Peterson Creek and Aquifer - Review of Ajax Mine Permit 3904 for Reliably Characterizing and Preventing Water Contamination by Existing Mine Wastes

Kamloops Area Preservation Association (KAPA)
Kamloops, British Columbia

Kevin A. Morin, Ph.D., P.Geo., L.Hydrogeo.
Minesite Drainage Assessment Group
A Division of Morwijk Enterprises Ltd.
Surrey, British Columbia
www.MDAG.com

April 15, 2020

Figure 2-2. Google Earth map showing existing components from the old Ajax Minesite and the surface-water monitoring stations required by Permit 3904.

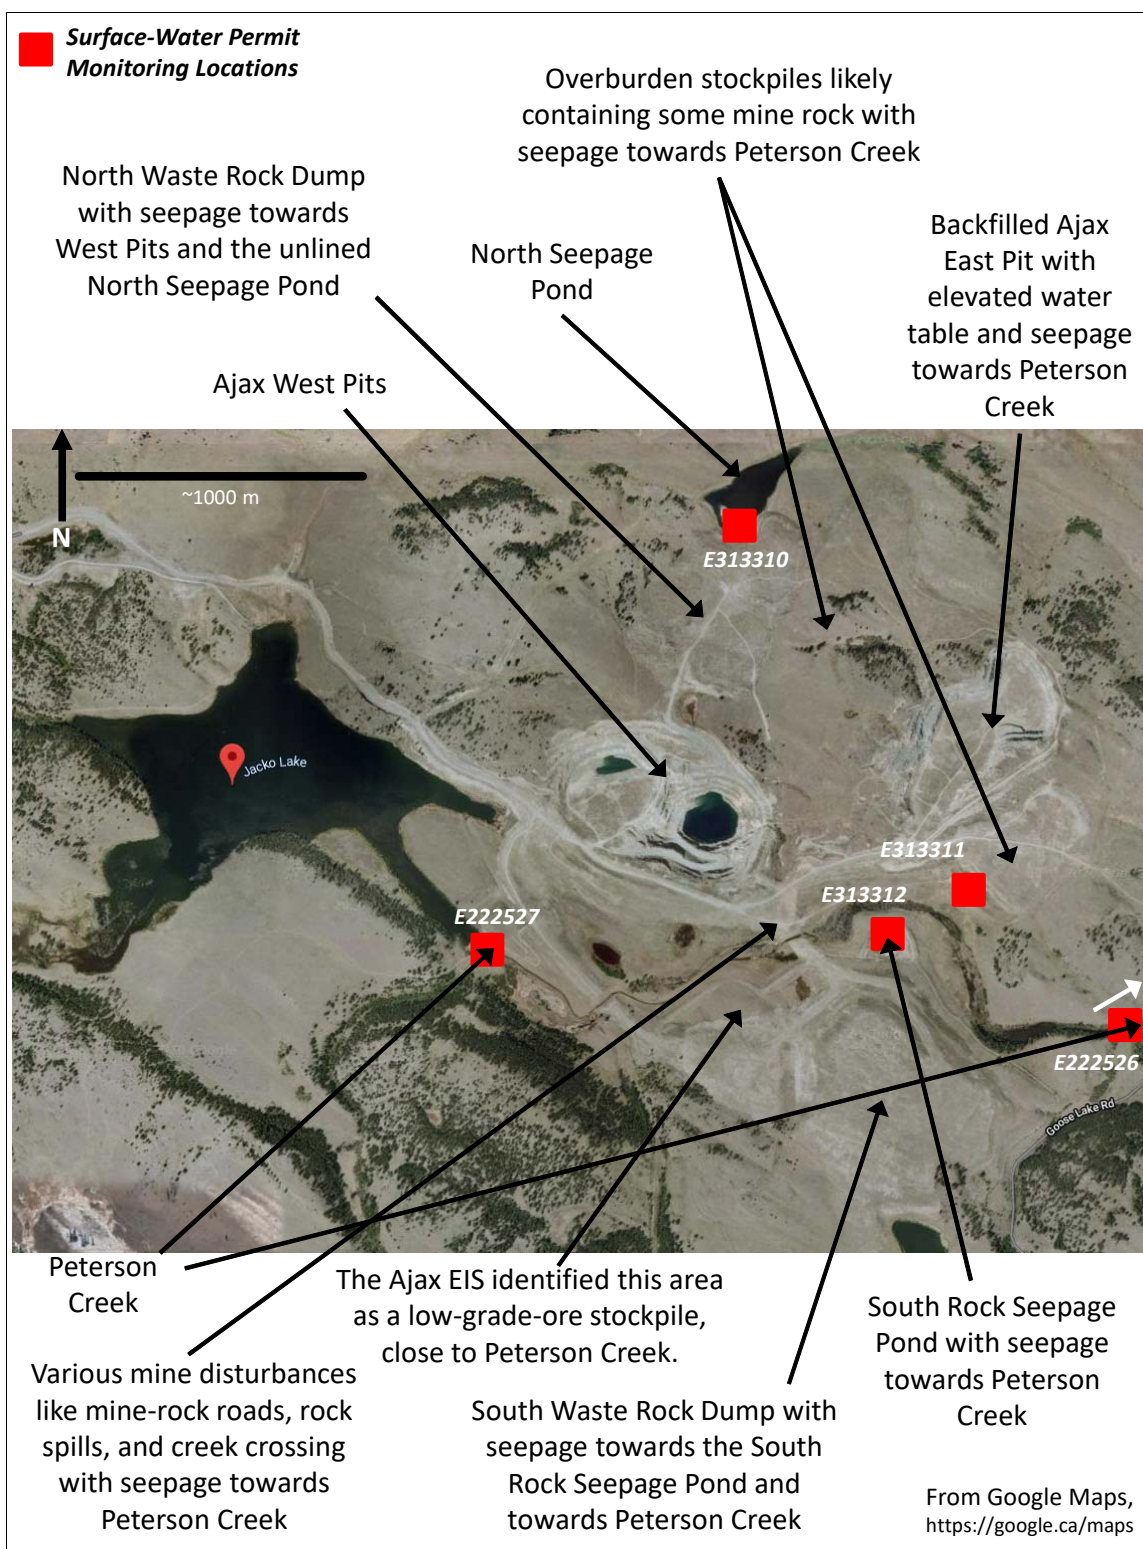
This list in Table 2-1 is important, because Permit 3904 does not recognize and does not require monitoring of many of these potential sources of water contamination.

For the chemistry of water leaving the old Ajax minesite components, Section 4.1 of Permit 3904 specifies that five surface-water sites will be sampled for chemistry (shown above as red boxes in Figure 2-2 of this review and listed below in Table 3-1). As explained in Chapter 4 below, these are insufficient to characterize contaminant release and transport from the old Ajax Minesite components.

Figure 4-1. Aqueous concentrations of sulphate in Peterson Creek upstream and downstream of the old Ajax Minesite, showing substantial increases downstream.

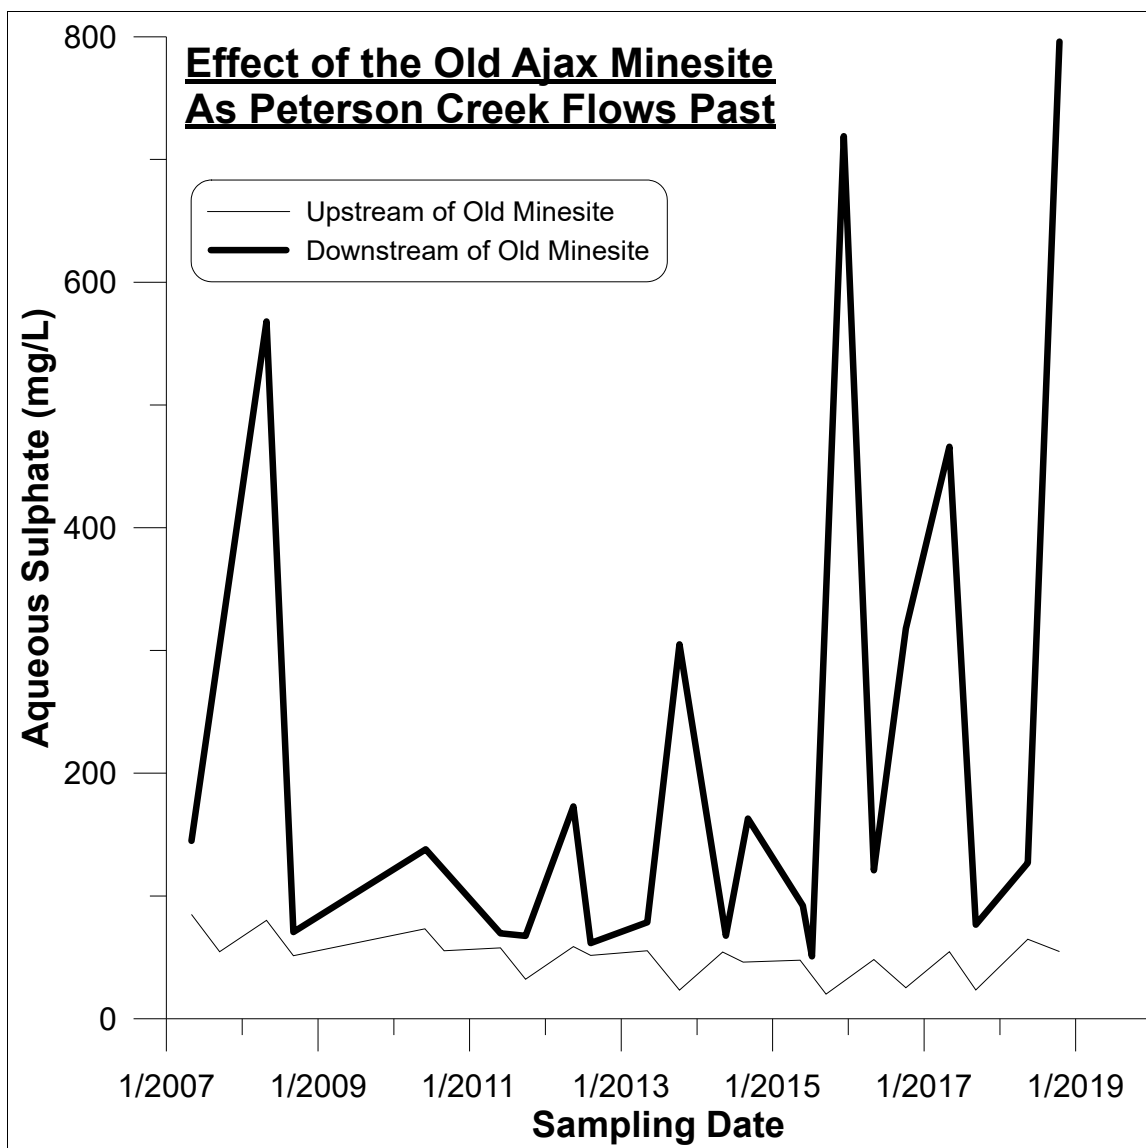
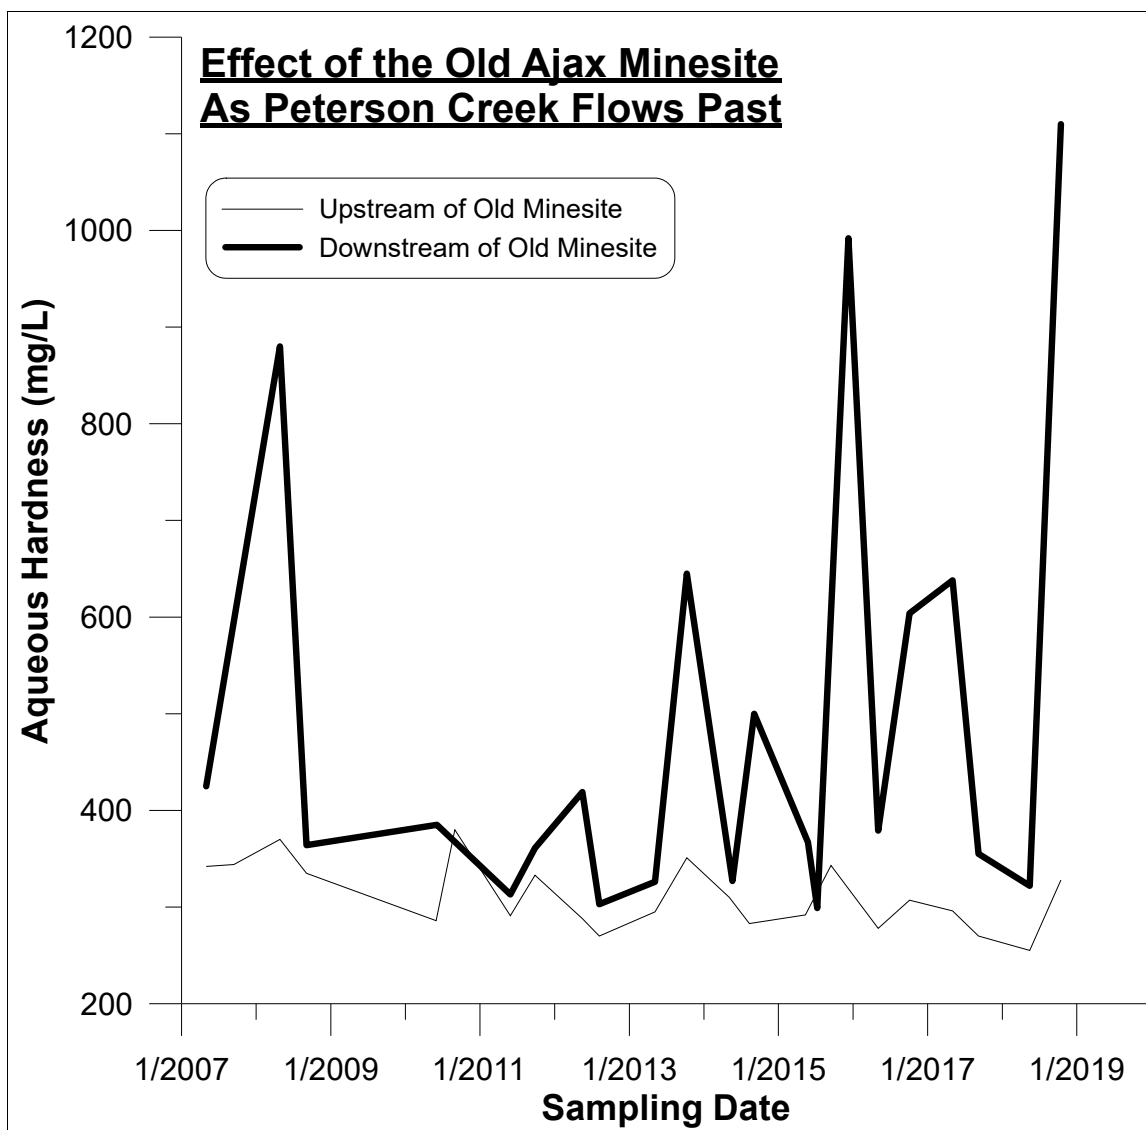
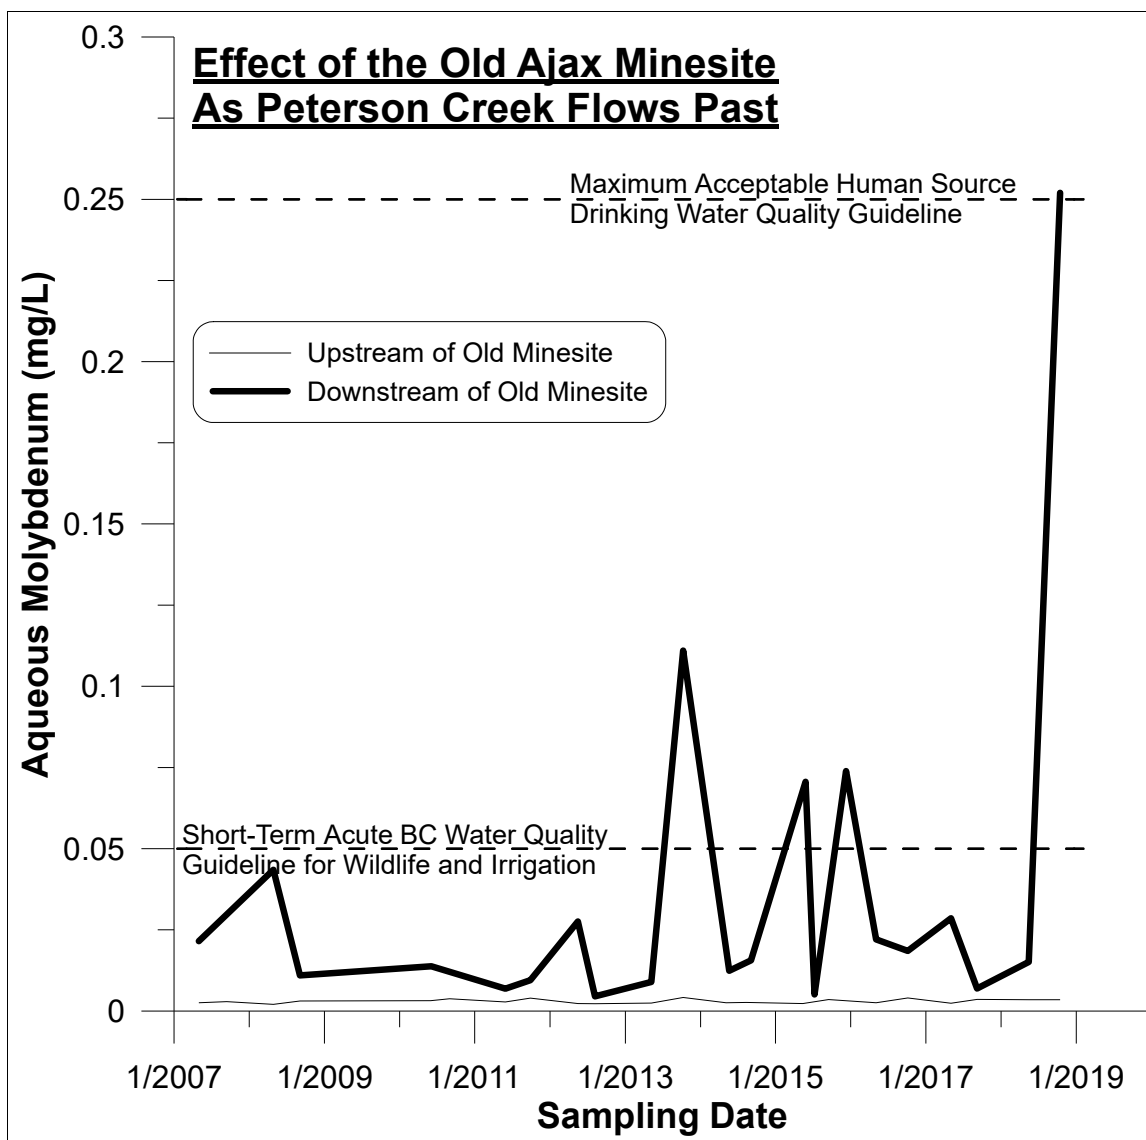
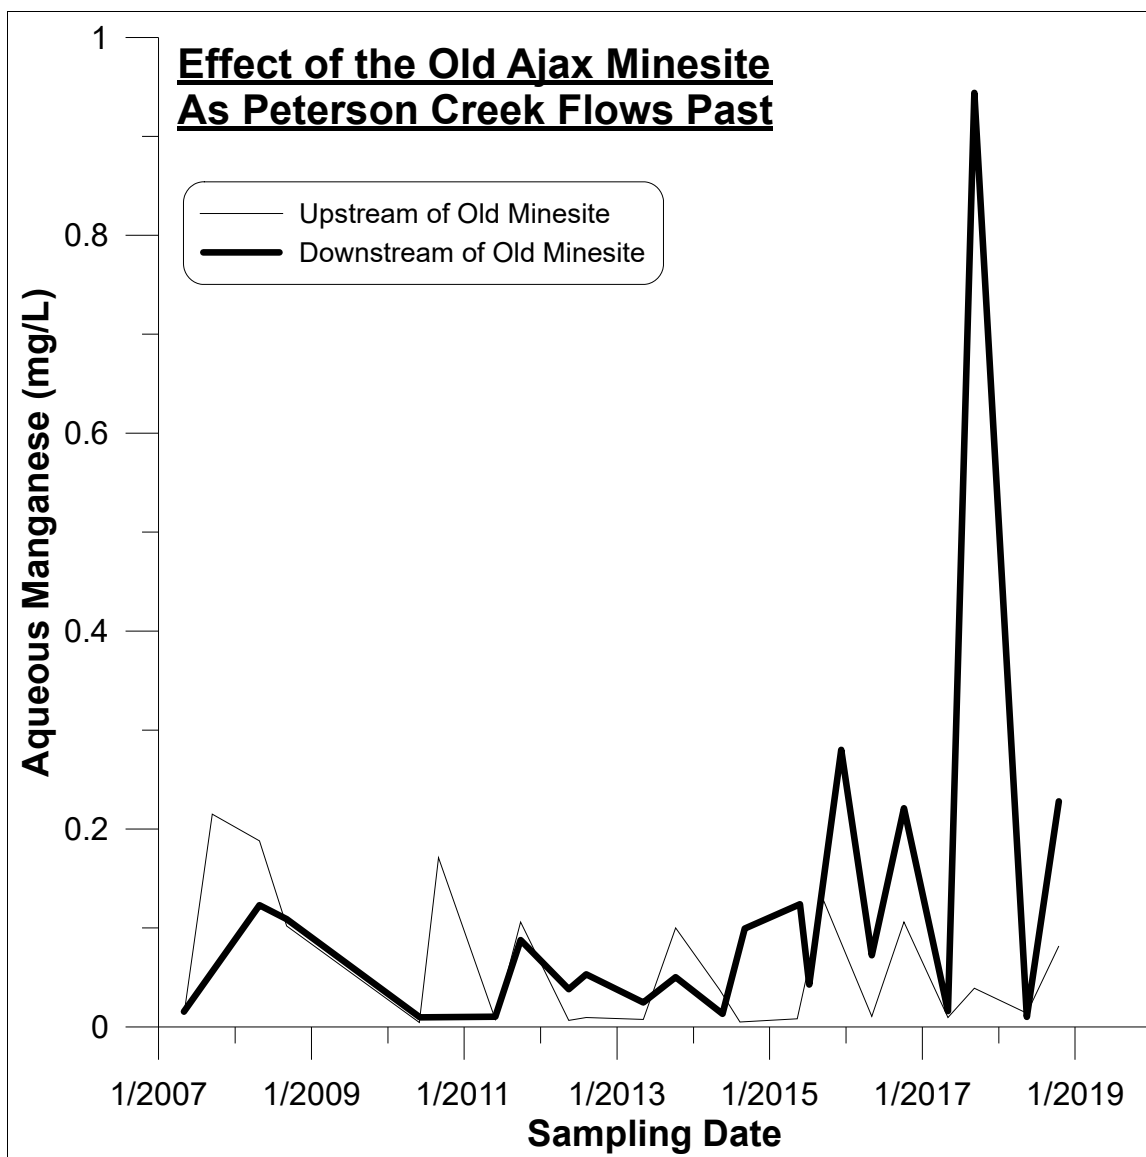
However, this verbal comparison does not show the true, dramatic effect of the old Ajax Minesite on Peterson Creek. To show this, the water analyses between 2007 and 2018 were plotted for selected analyses (Figures 4-1 to 4-4), particularly sulphate and molybdenum which is expected from Ajax rock (see Chapter 2 above). As an example of comparisons to water-quality guidelines, downstream peak molybdenum concentrations exceed the Short-Term Acute British Columbia Water Quality Guideline for Wildlife and Irrigation (0.05 mg/L). Also, the most recent molybdenum peak exceeds the Maximum Acceptable Human Source Drinking Water Quality Guideline of 0.25 mg/L.

This may account for the seasonal peak contaminant concentrations detected downstream in Peterson Creek (Figures 4-1 to 4-4). However, monitoring under Permit 3904 is inadequate to characterize this variability and even to reliably show it is happening.

Section 4.2 of this review and Figures 4-1 to 4-4 already show this common assumption is wrong. However, there is more conclusive evidence.

Figure 4-5. Aqueous concentrations of molybdenum in Peterson Creek downstream of the old Ajax Minesite, copied directly from a permit monitoring report (Knight Piesold, 2020), which should match the heavy line in Figure 4-3 exactly but instead shows errors in the KGHM monitoring database.

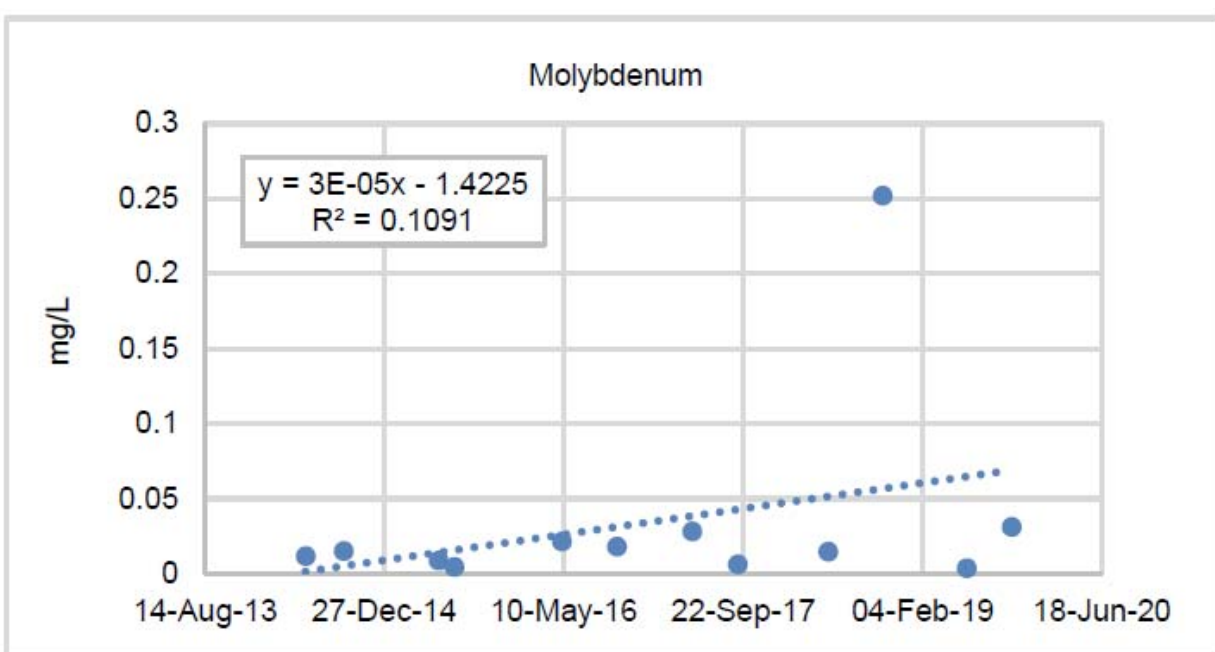
Alarmingly, many of the downstream molybdenum peaks above 0.05 disappeared in the 2019 report (Knight Piesold, 2020) which is copied in Figure 4-5. Therefore, there are discrepancies in water analyses among the permit reports, which raises uncertainty on the actual degree of contamination.

Figure 5-4. Map of the shallow water table around the old Ajax Minesite, showing groundwater moving towards Peterson Creek and not being captured by the Ajax West pits (adapted from BGC, 2015).

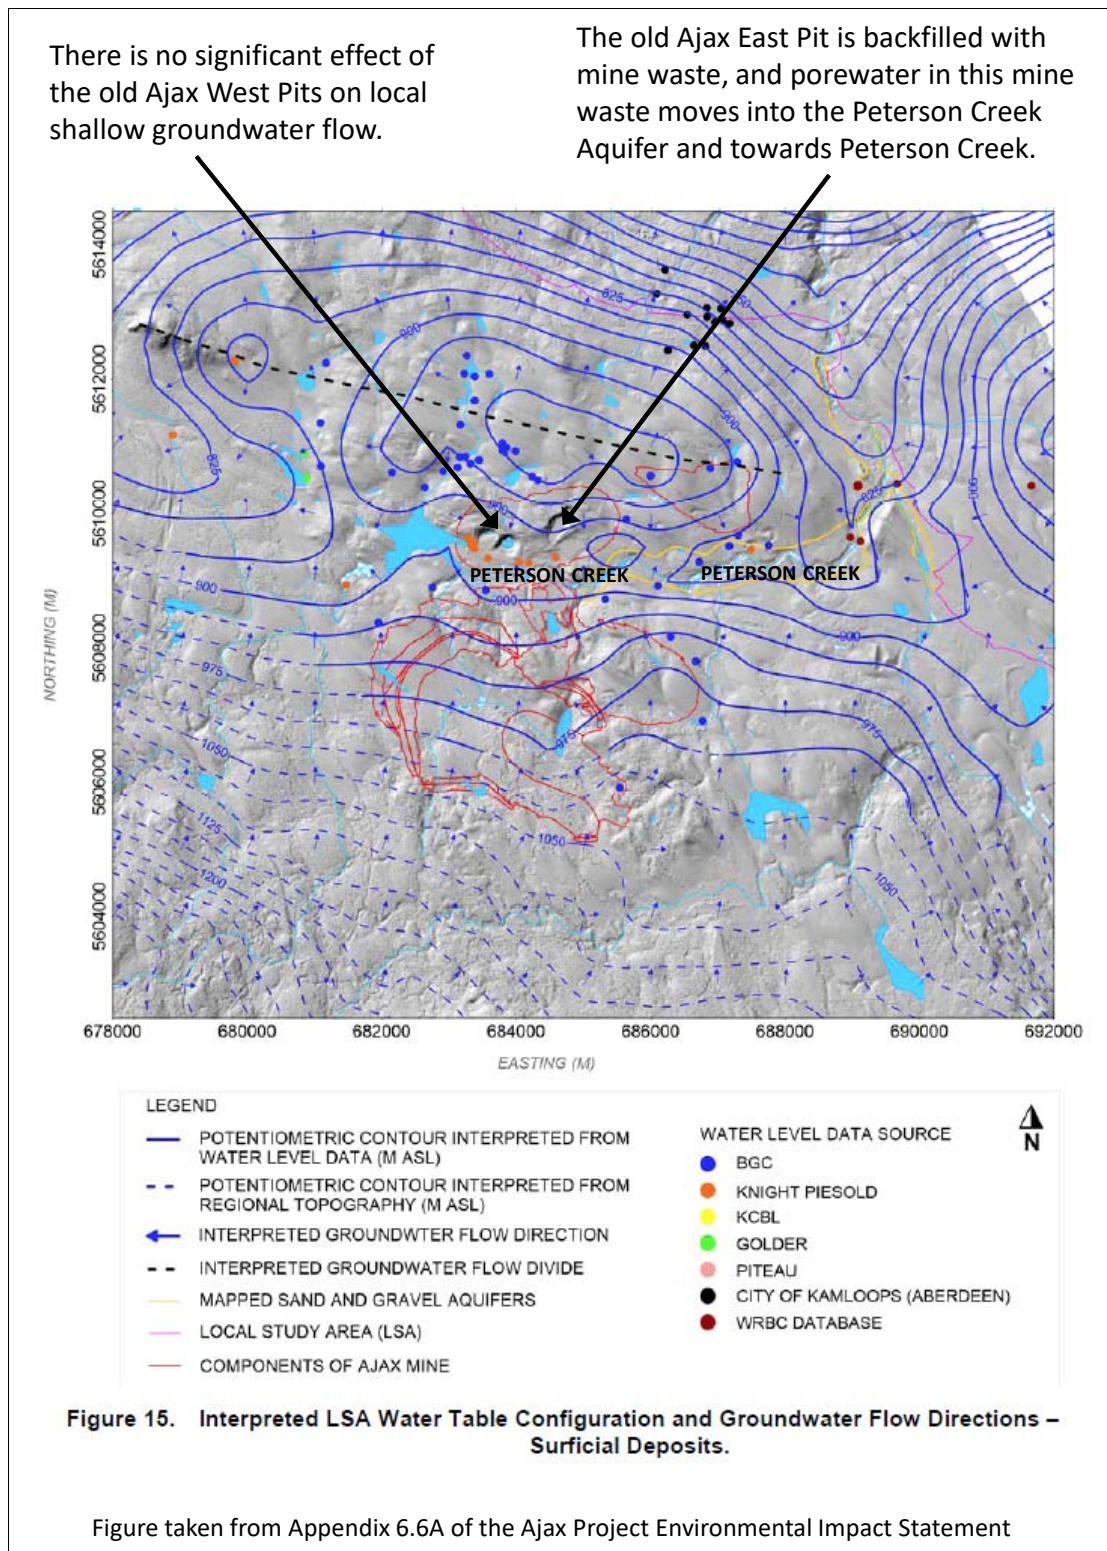
Dozens of monitor wells and piezometers, some measured for groundwater elevation hundreds of times over two years, show these pits have no detectable effect on groundwater flow through the old minesite, at least 150 m outside their perimeters. This applies to both shallow groundwater (Figure 5-4) and deeper groundwater (Figure 5-5).

There is no significant effect of the old Ajax West Pits on local bedrock groundwater flow; the 900 m groundwater contour passes between the two pits.

The old Ajax East Pit is backfilled with mine waste, and porewater in this mine waste moves into the Peterson Creek Aquifer and towards Peterson Creek.
